AGENDA
Design Review Committee
February 14, 2024 – REGULAR MEETING

Item Number: P24-014

Applicant: Mogul Hospitality Partners – Jackson, LLC

Recommendations: Final Conceptual Review (Sketch Plan)

FLOOR PLAN - LEVEL B1

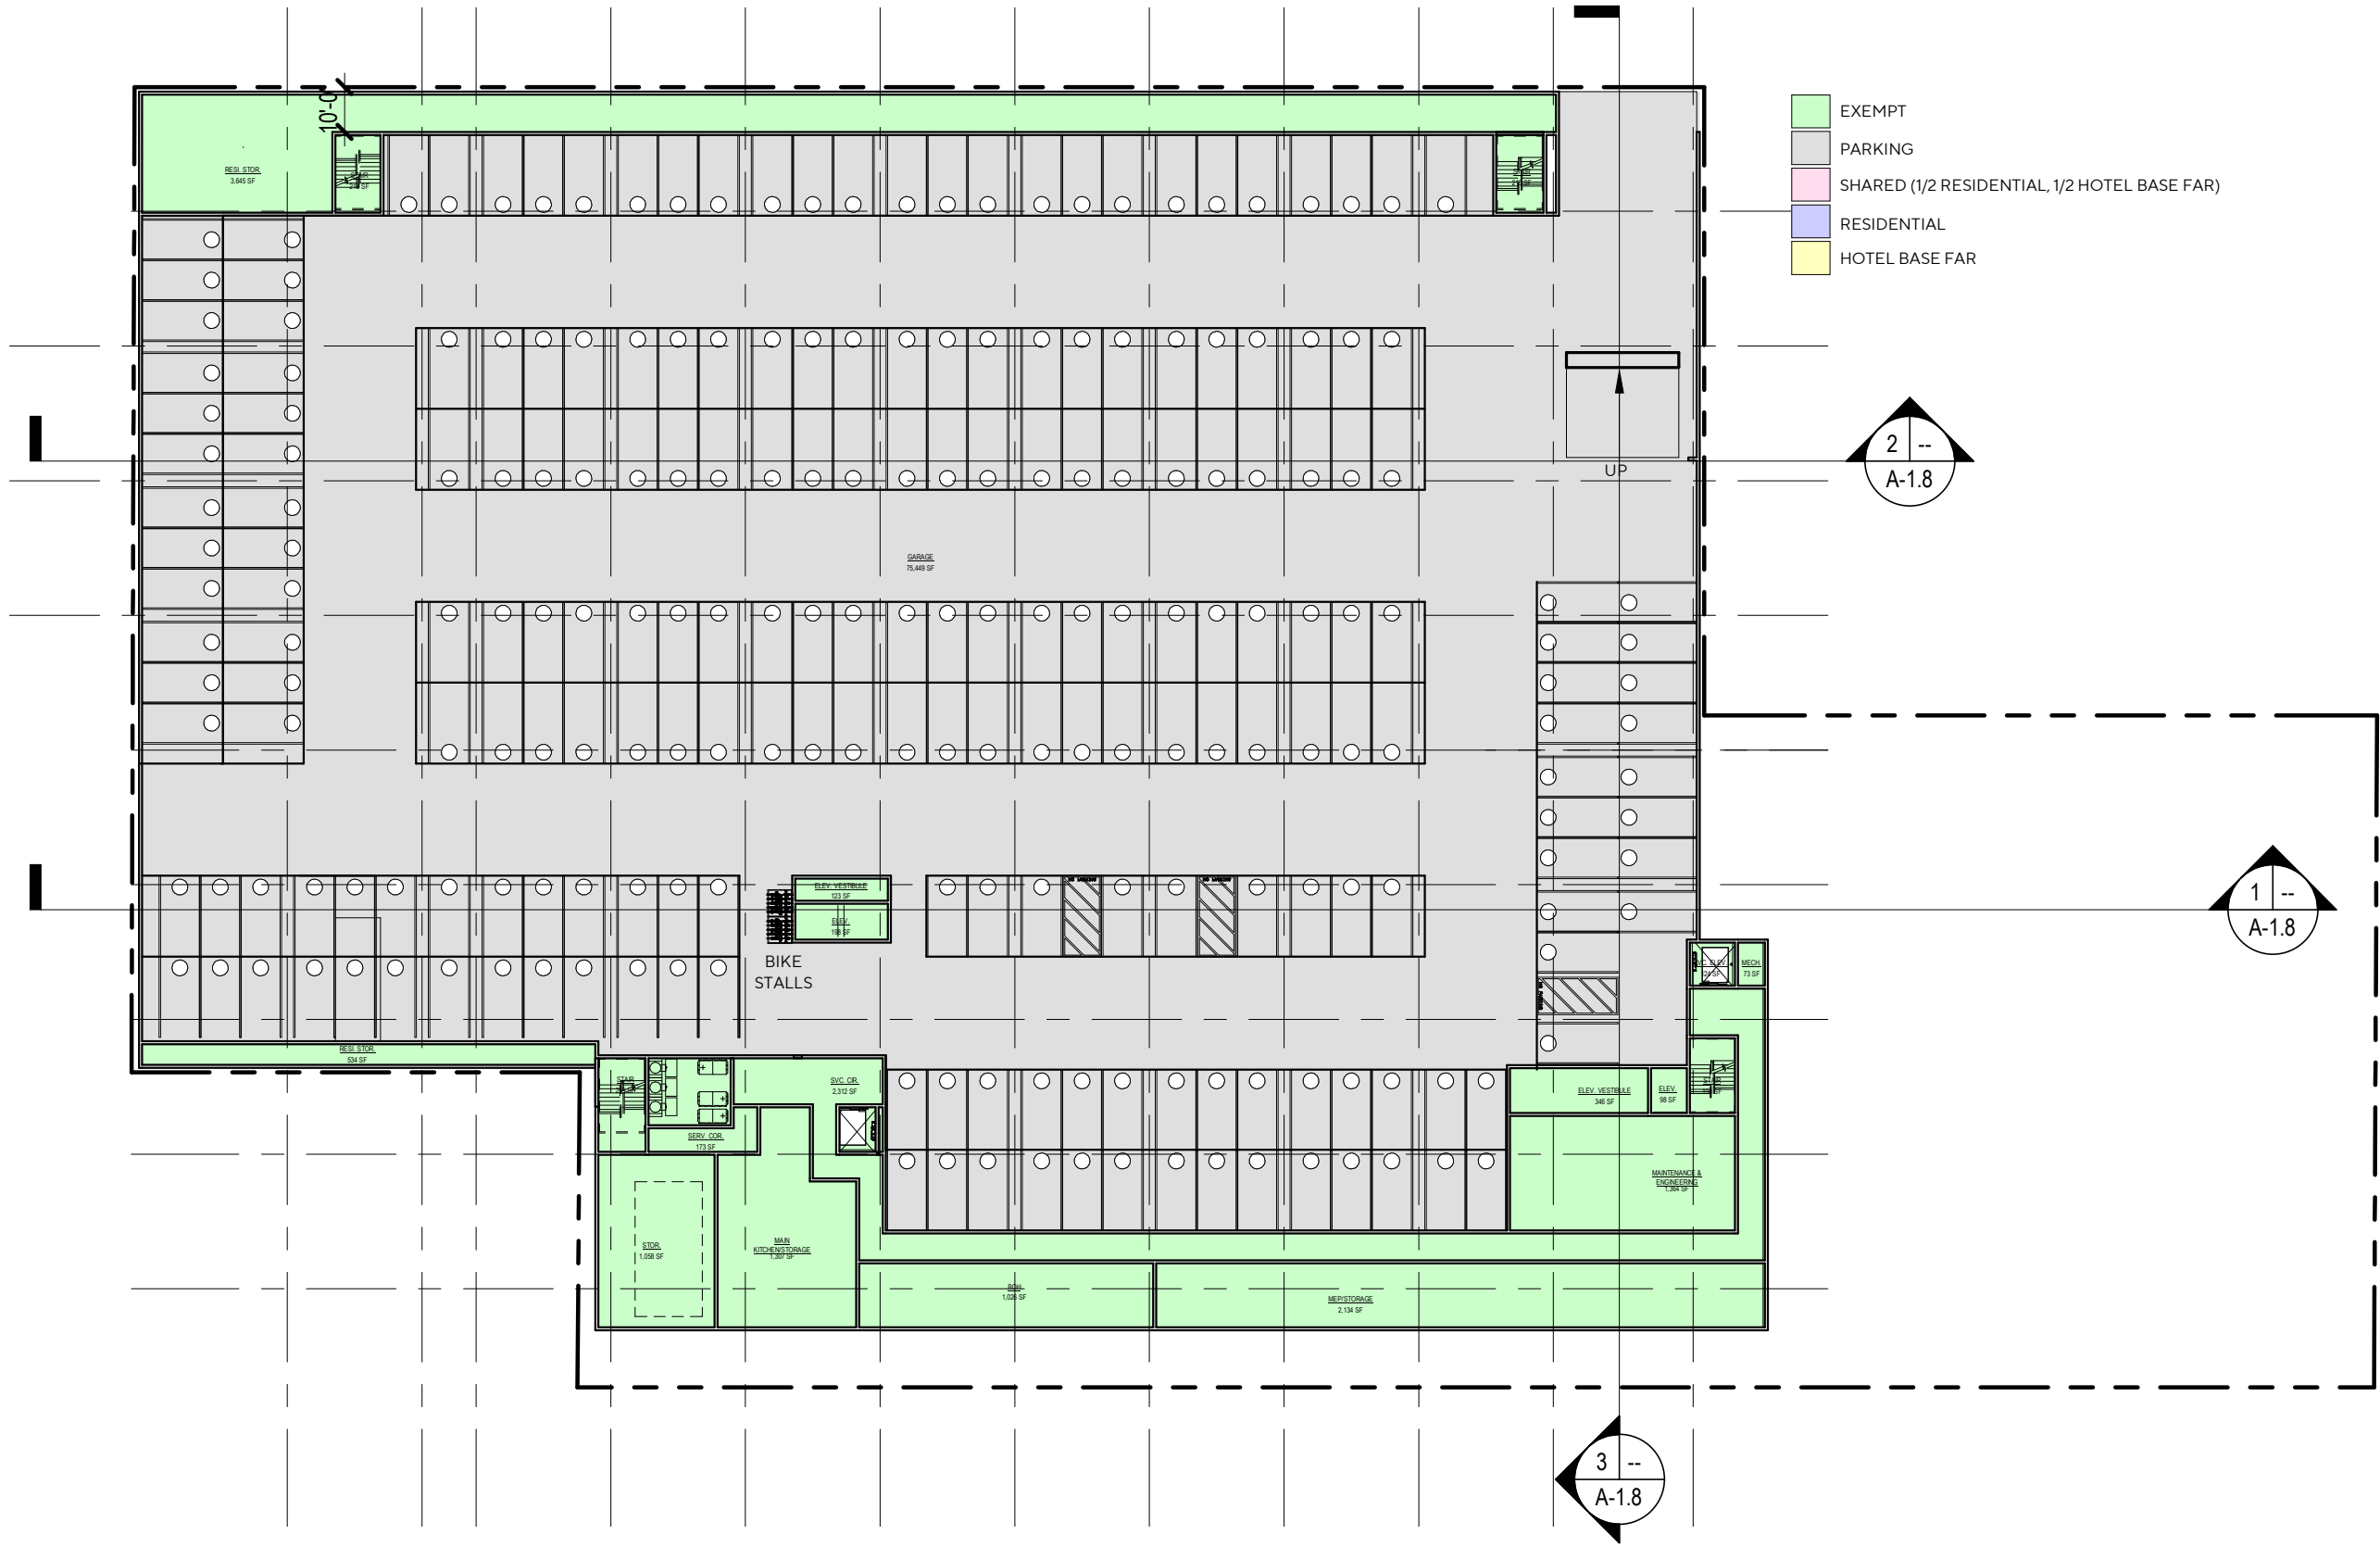
6. **3rd FLOOR STEPBACK:** it does not appear that the 3rd floor stepback requirement is being met along Glenwood.
7. **LEVEL B1:** staff has not confirmed if the basement walk-out patios on Cache, Mercill, Perry, and Glenwood, are within the 13.5' pedestrian

- frontage. If they are, they need to be shifted to be located outside of the pedestrian frontage. The pedestrian frontage is not for walk-out basements.
8. CURB CUTS: The curb cuts along Cache appear to be wider than the maximum 24' per curb cut. Need to verify with the applicant.
 9. PARKING: Staff needs to confirm how the parking will be managed and who will use the tandem spaces.
 10. EV PARKING: A total of 65 spaces need to meet the EV parking standards. This means that 11 need to be EV installed, and 54 need to be EV capable.
 11. ADA PARKING: A total of 7 ADA spaces are required. Only 6 have been provided.

CACHE STREET FACADE ELEVATION

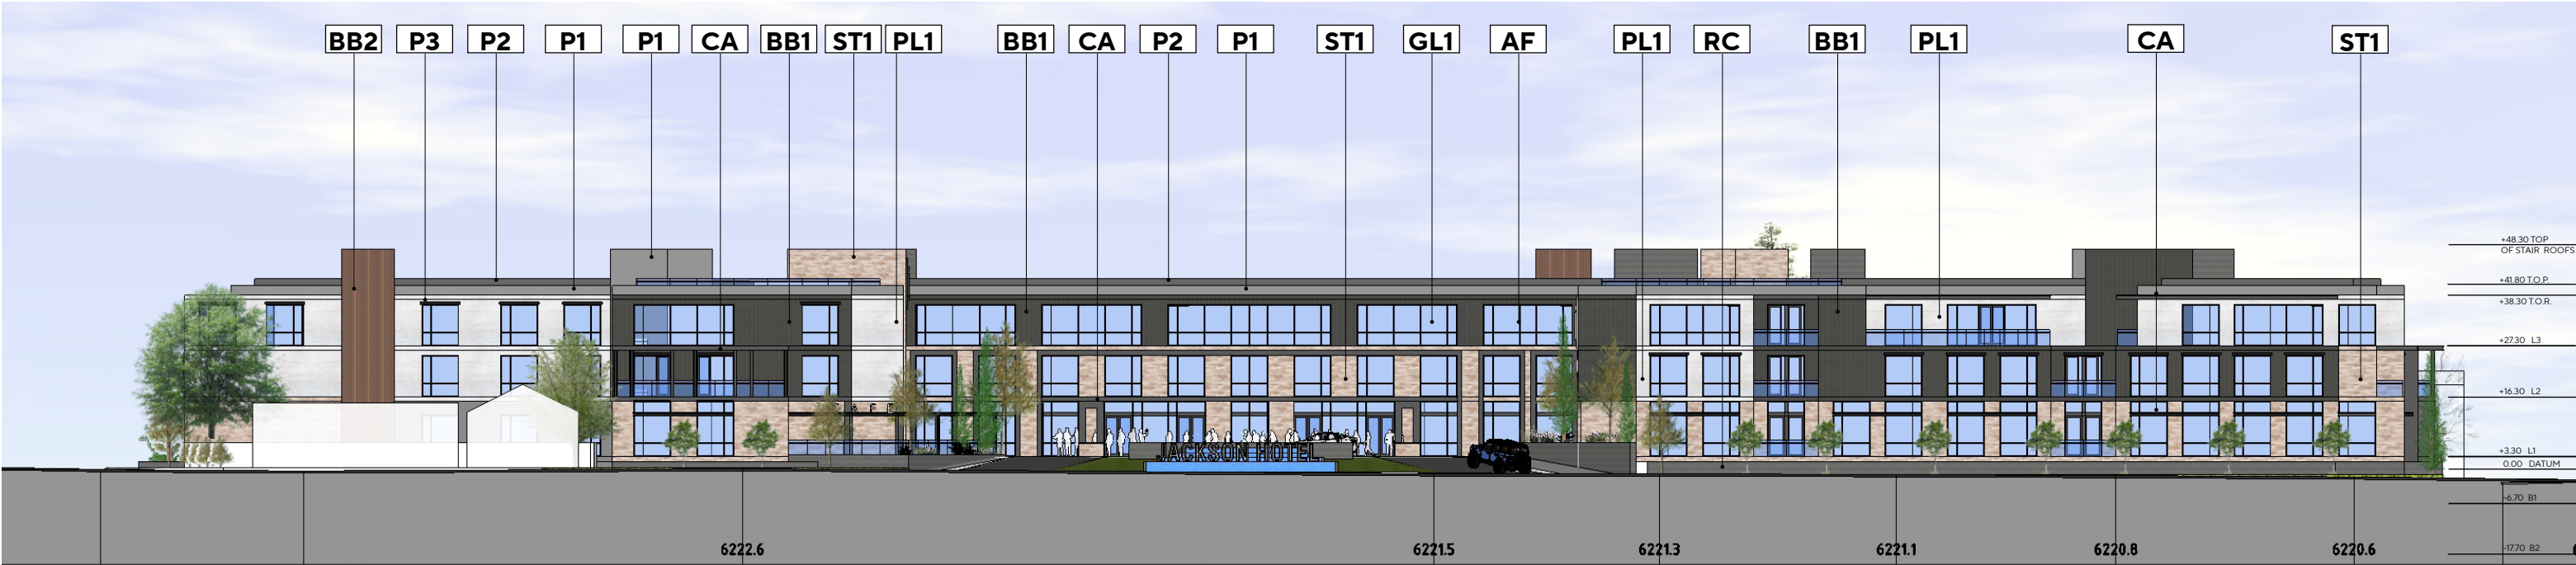
2. **FORECOURT:** The vehicular courtyard off North Cache is only allowed if it is considered a forecourt, and staff has not yet confirmed if it meets the definition of a forecourt. Forecourts can count toward the minimum 80% frontage requirement but they cannot be wider than 1/3 of the building and must be within 30" of finished grade. The proposed forecourt does not appear to comply with either standard.

3. **PEDESTRIAN IMPROVEMENTS:** The sidewalk along North Cache needs to carry straight across the two driveway entrances for the above-mentioned forecourt. The proposed sidewalk that runs parallel to the vehicular courtyard as shown in the site plan can remain.
